# EXTERIOR ELEVATIONS

Planning Review By:  
 Name: Katie Posler  
 Phone: (480) 312-2703  
 e-mail: kposler@scottsdaleaz.gov  
 Review Cycle: 1 Date: 11/10/2021

Side / Drive Thru Window Elevation

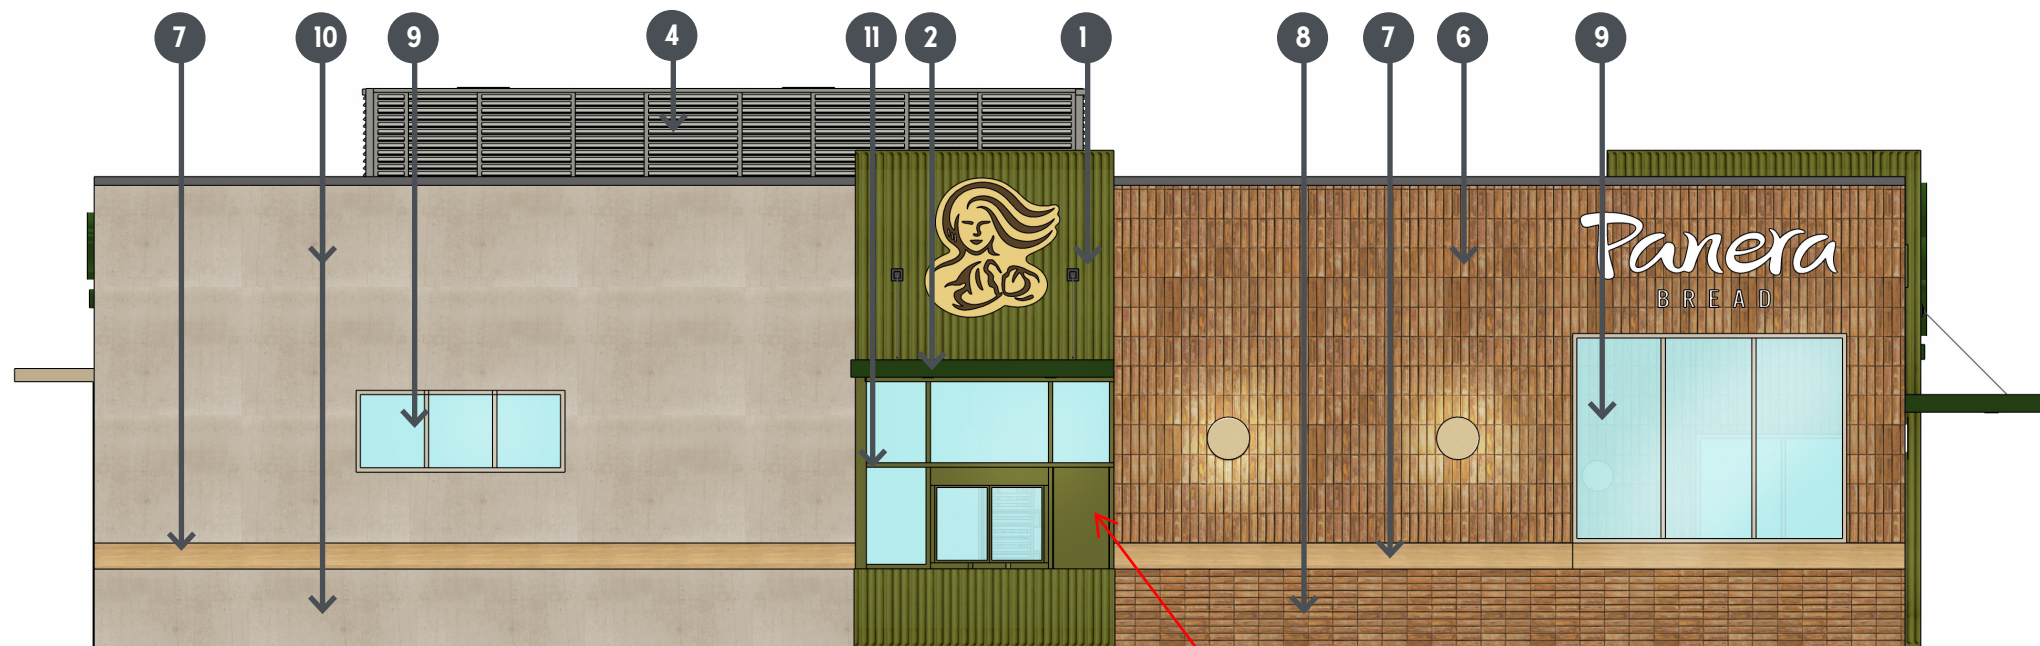
incorporate full canopy and posts over drive thru window

## Back / Drive Thru Queue Elevation

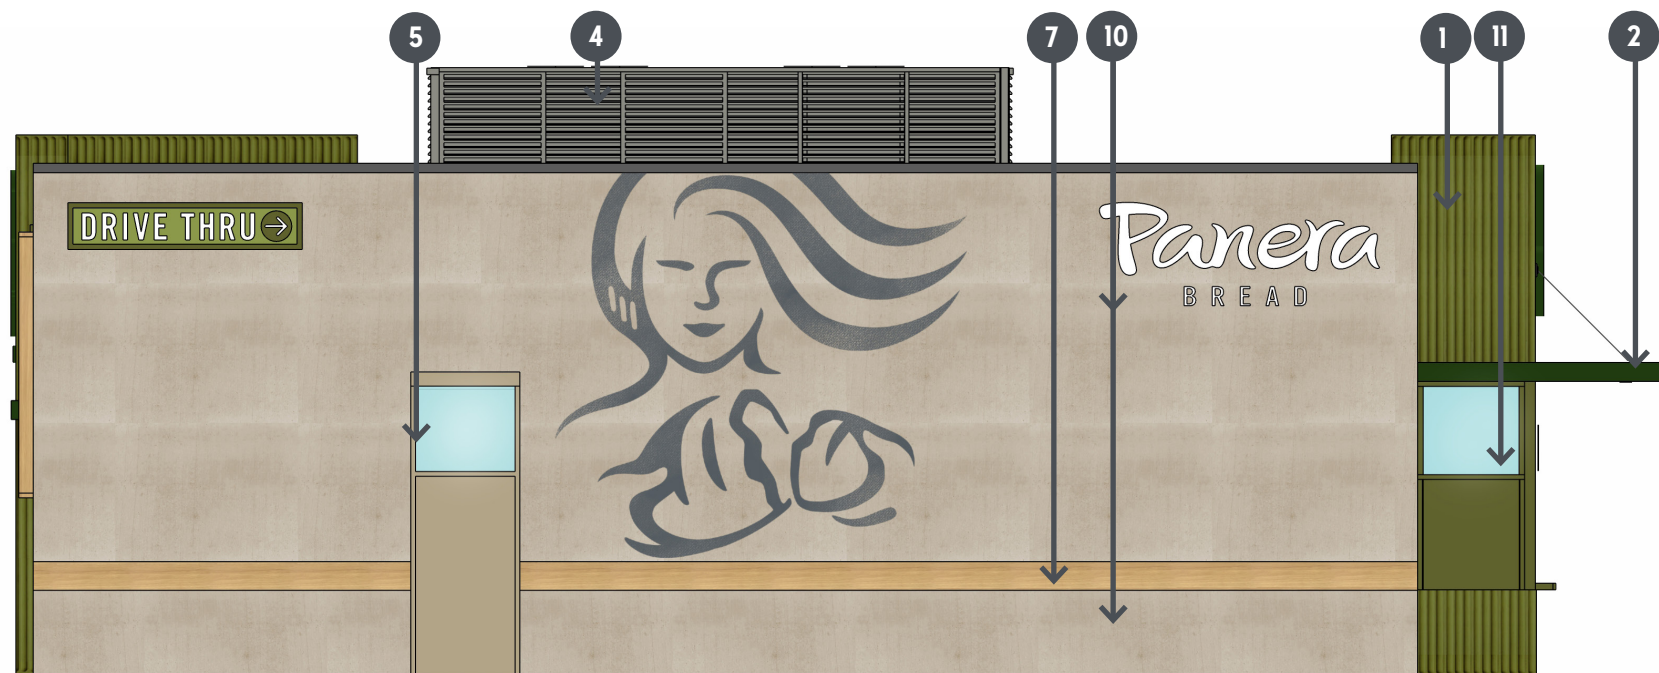
SES shall be recessed into building
